ADDENDUM NO. 1

DATE: AUGUST 5, 2025

SHEET:
A1-201

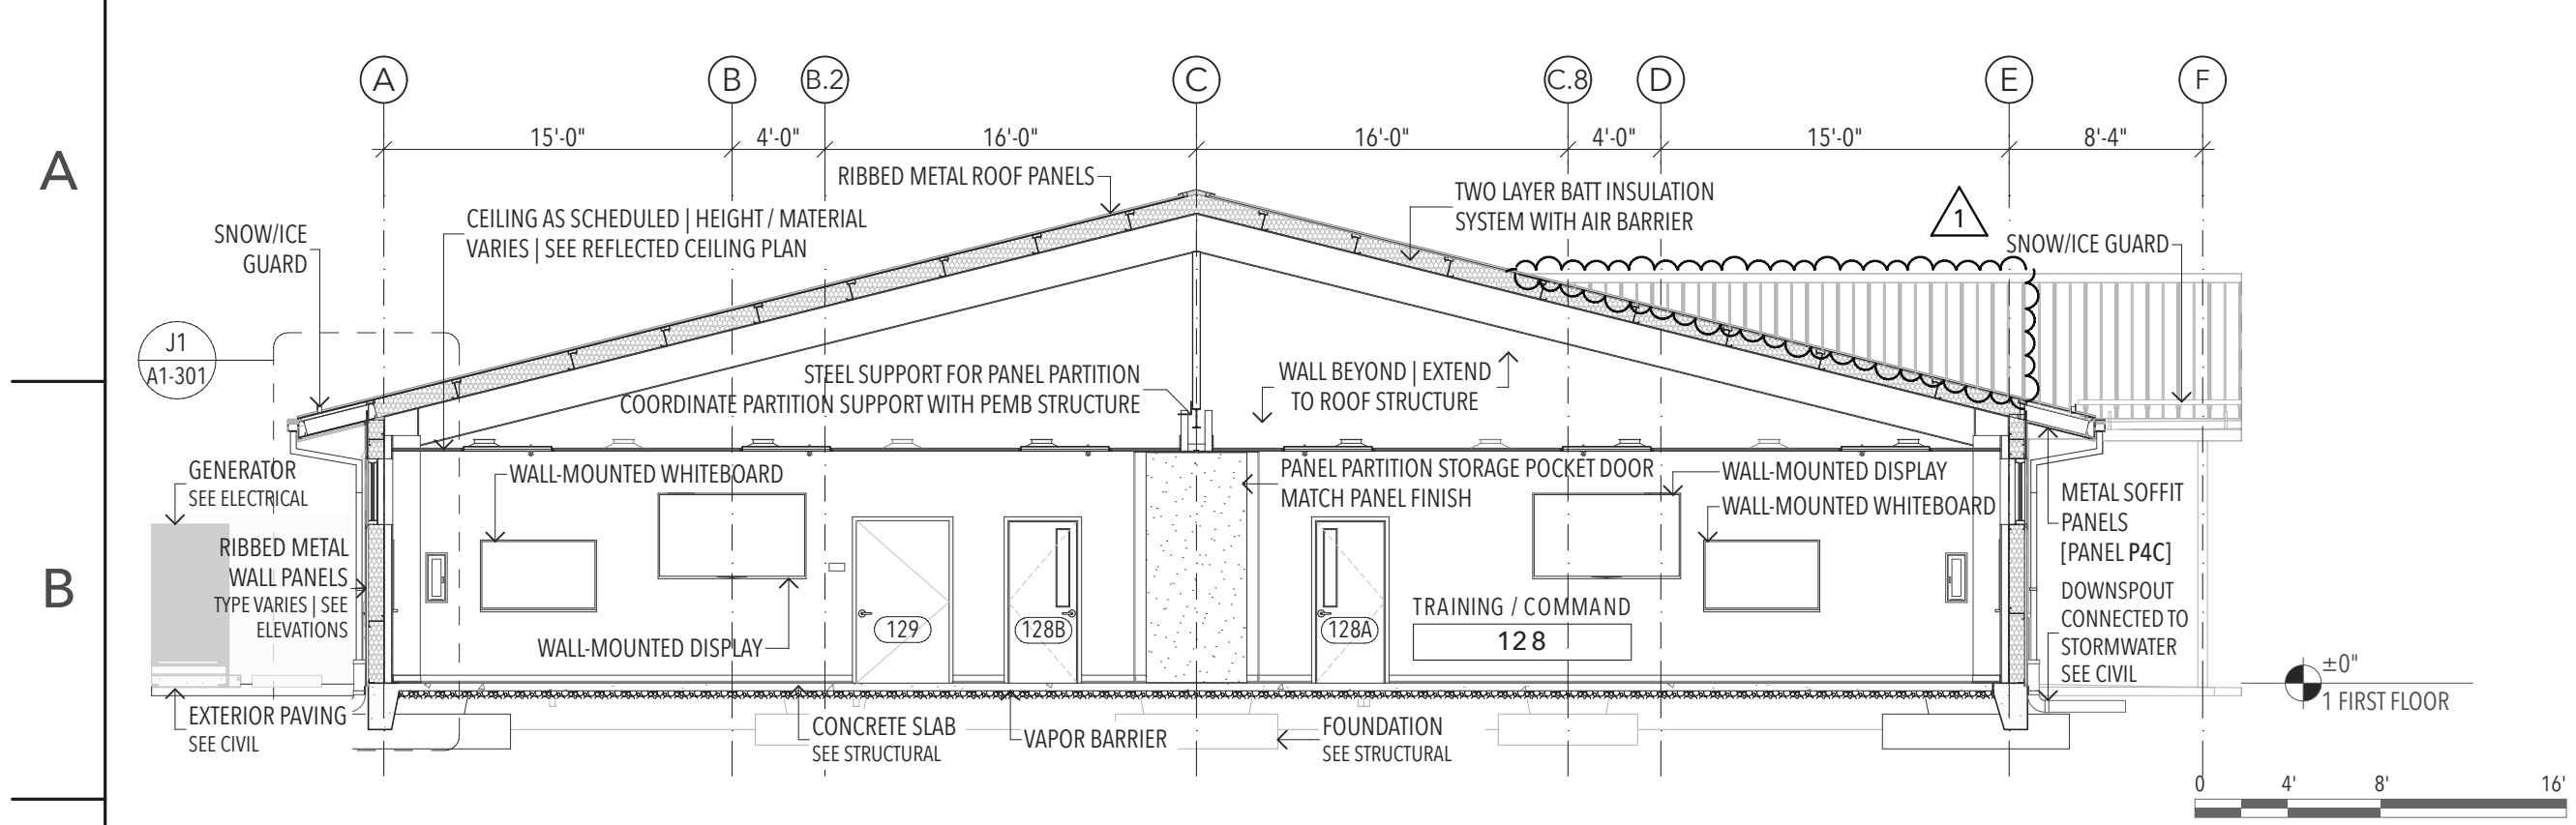
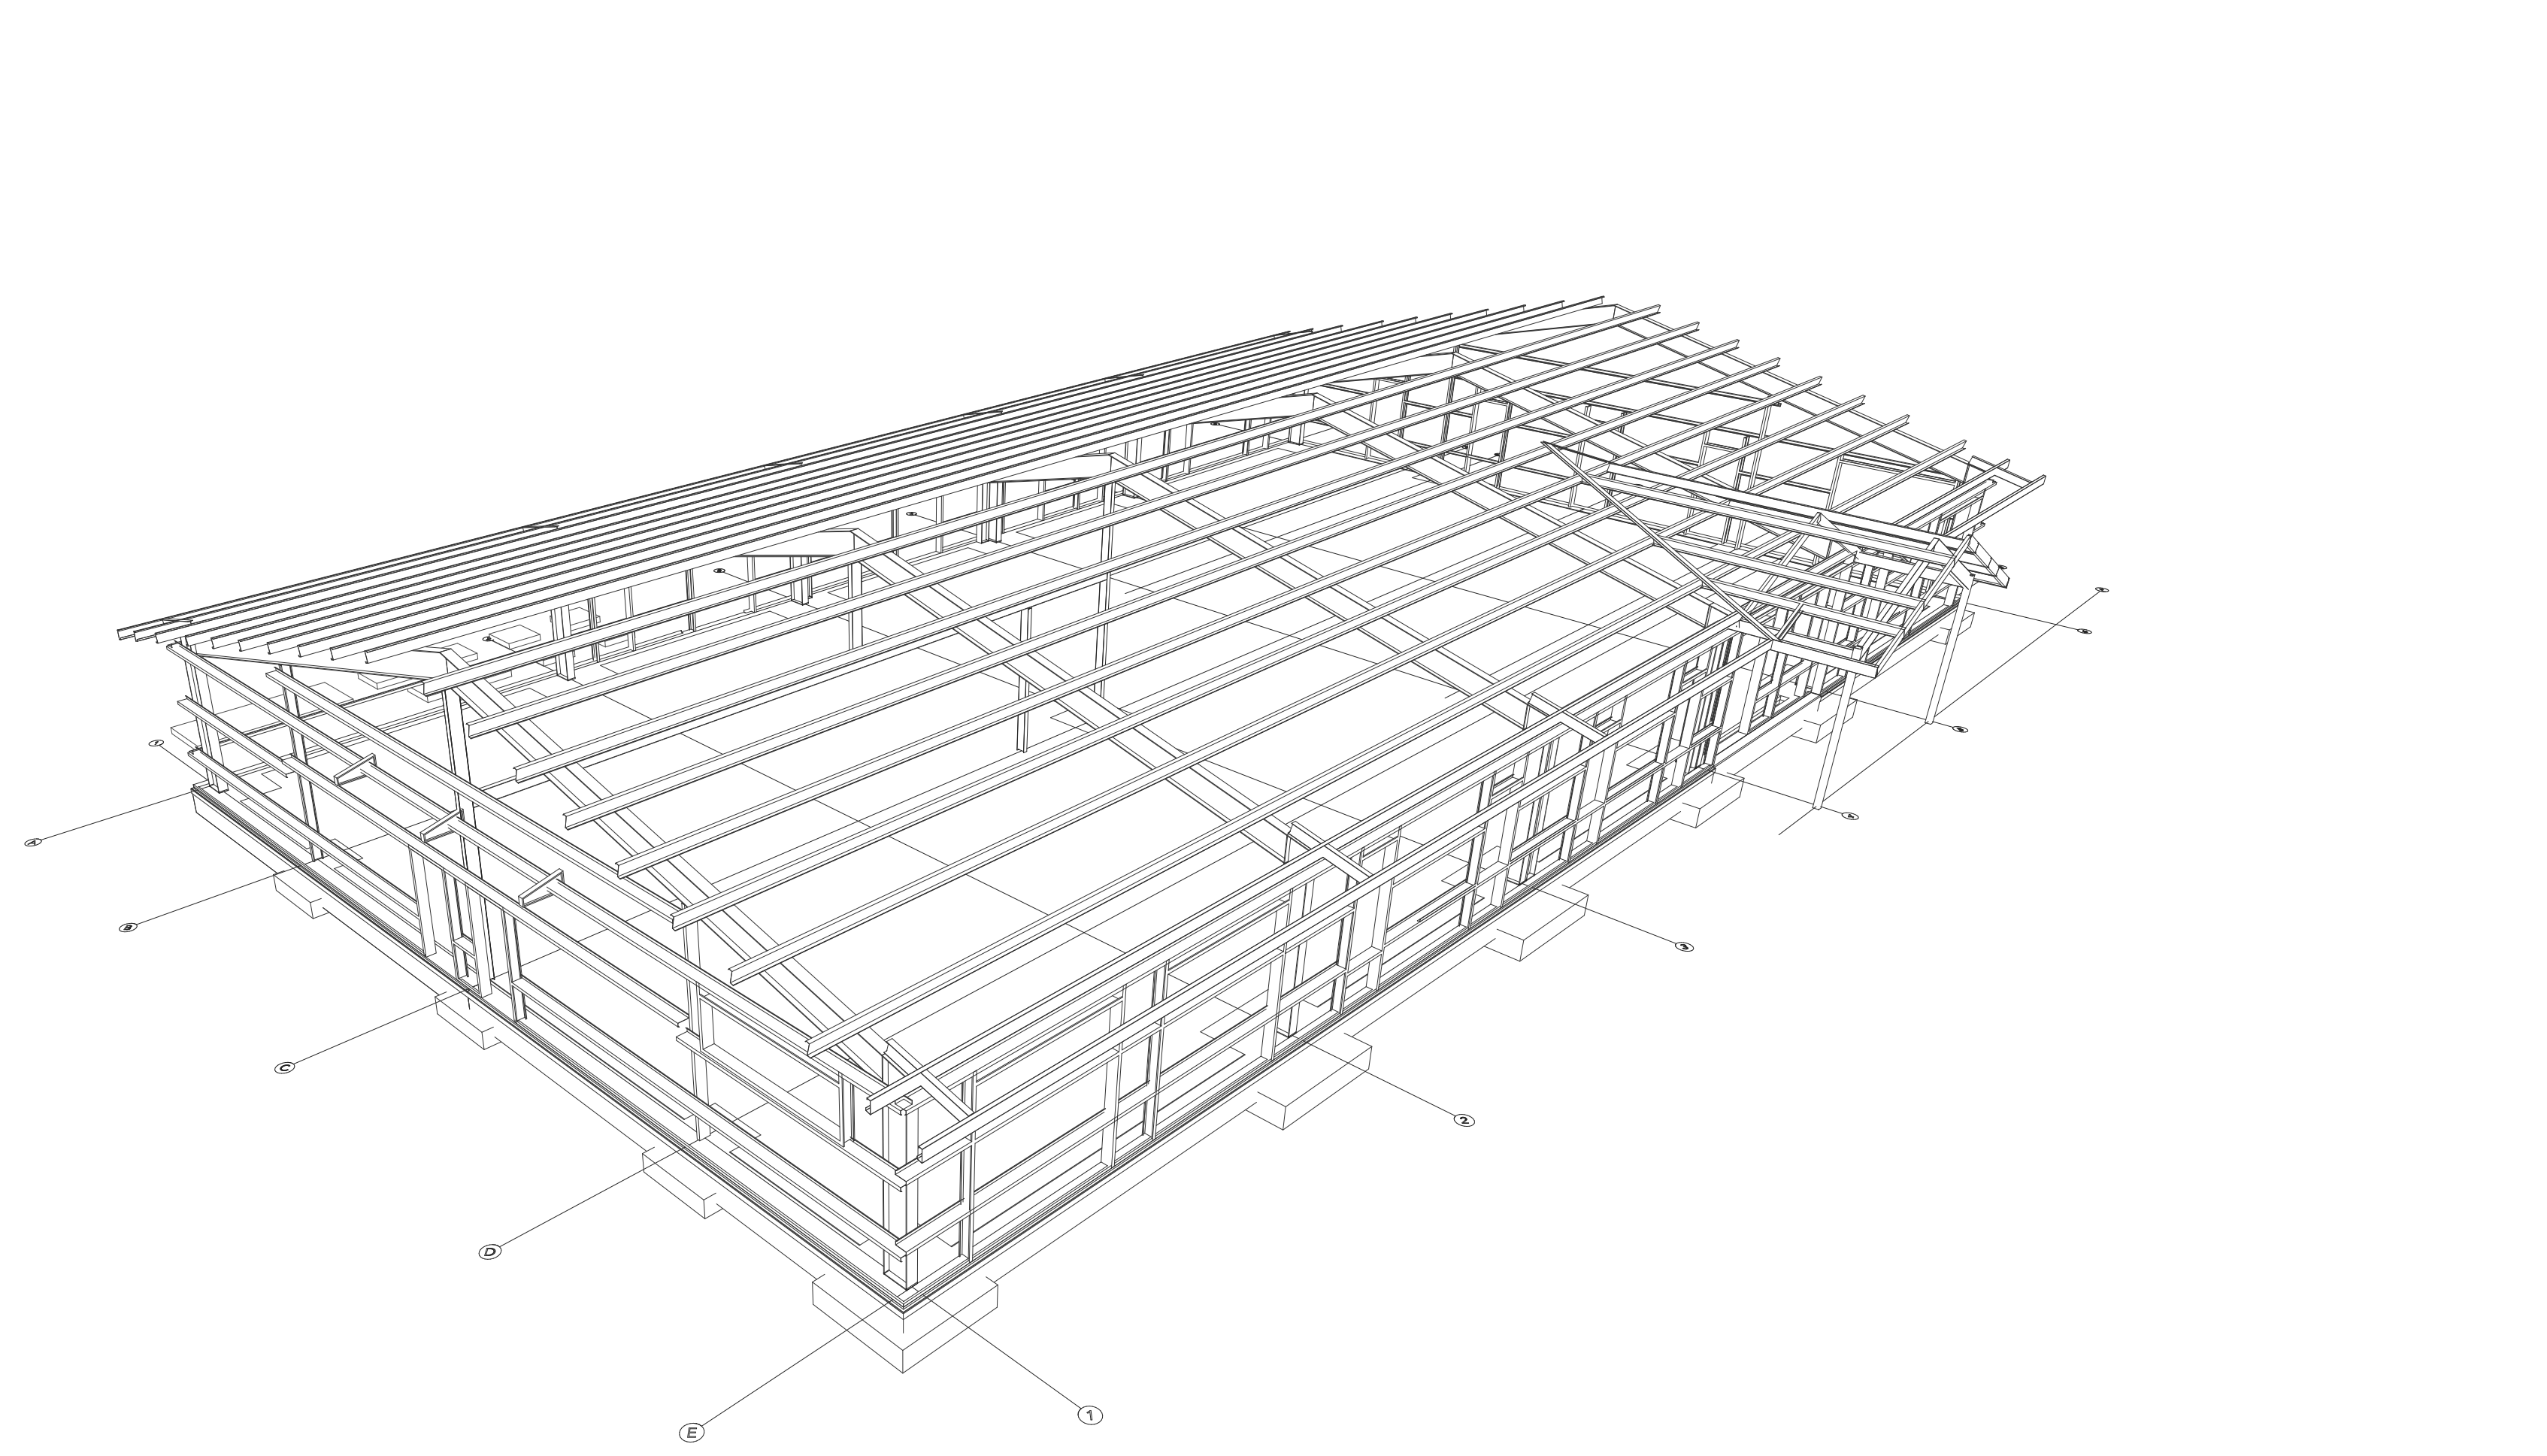
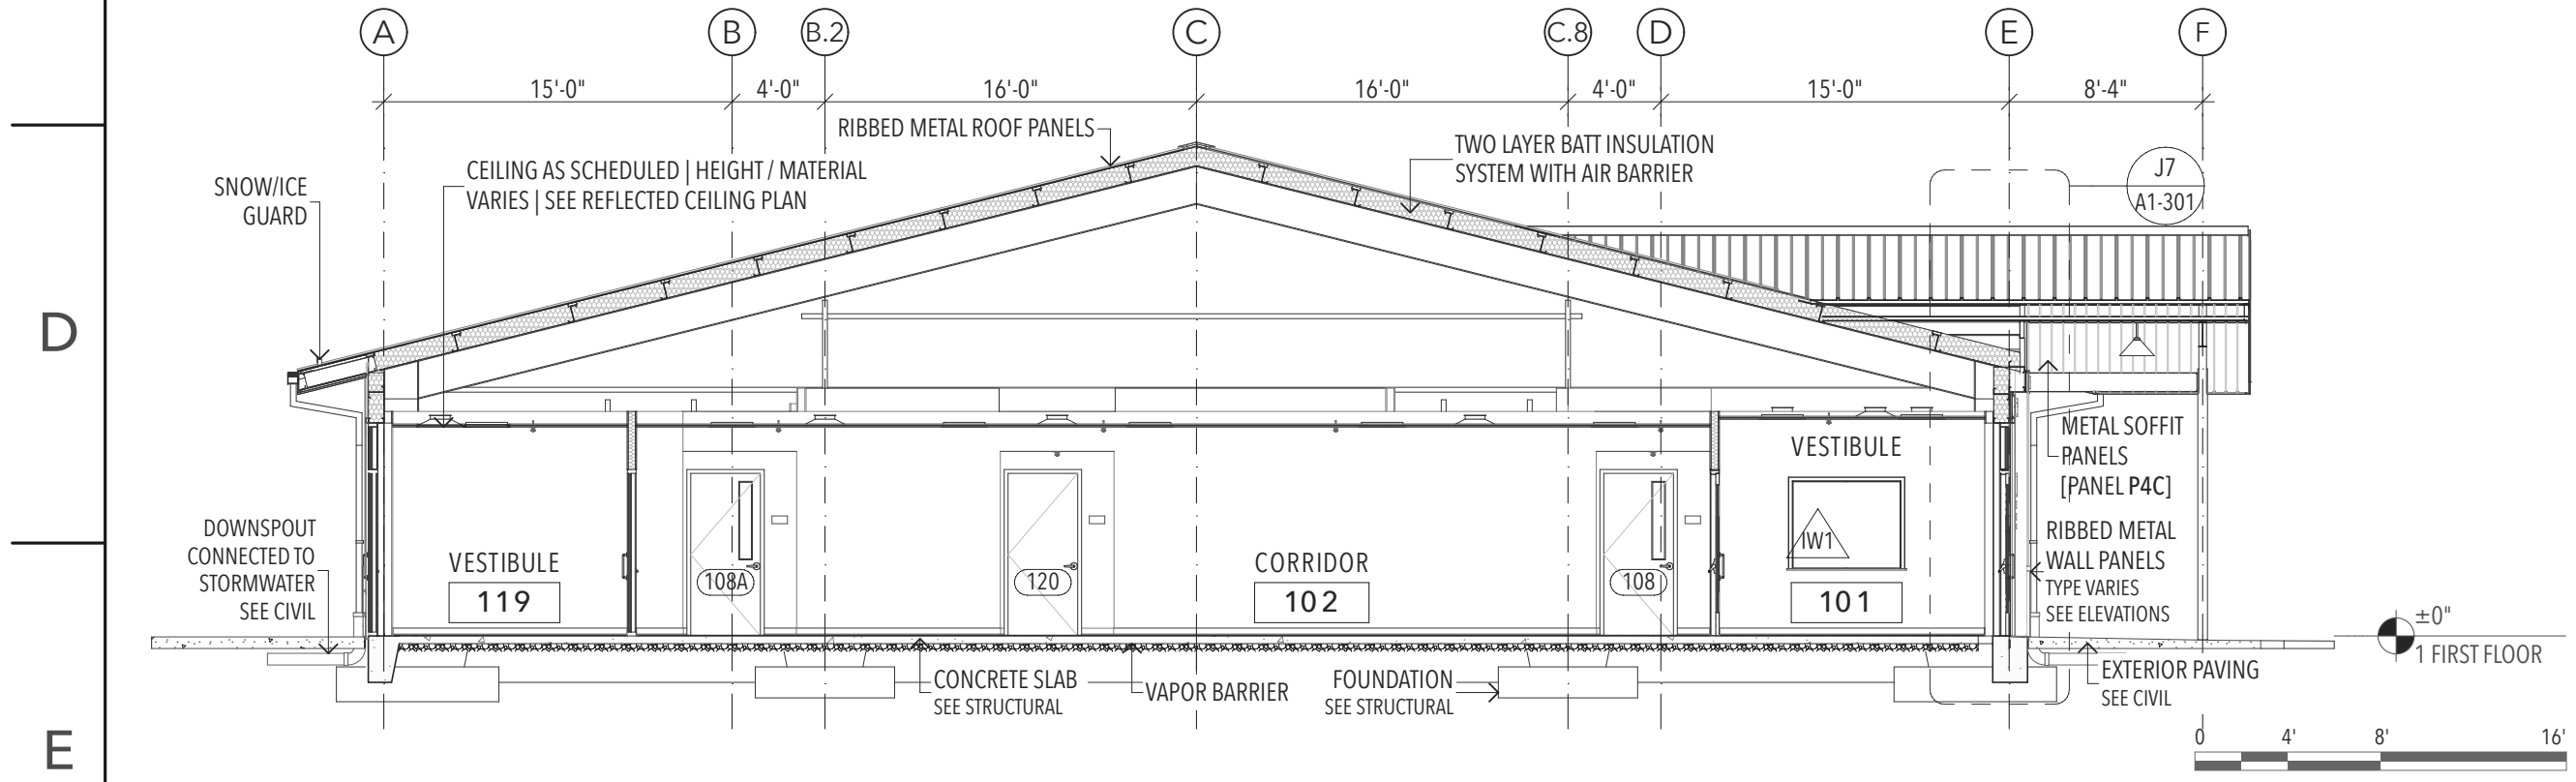
1. **REPLACE** Sheet A1-201 – Administration | Building Elevations with the attached, **UPDATED** Sheet A1-201 – Administration | Building Elevations (Revision 1, Dated 08/04/25). Drawing updated to address a graphic issue with how the south elevation covered entry is represented on the D1/A1-201 West Building Elevation and D8/A1-201 East Building Elevation.
2. **CLARIFICATION:** The P3C metal panels shown on Building 02-Maintenance Building above the Bay 201A, 201B, 201C, and 201D coiling doors are to have the same finish / match the wood grain finish of the P3C and P4C metal panels on the Building 01-Administration Building. Panels P3C and P4C are also used at the southeast corner of Building 02-Maintenance Building. The P3C and P4C metal panels are included in Specification Section 074213- Formed Metal Wall Panels.
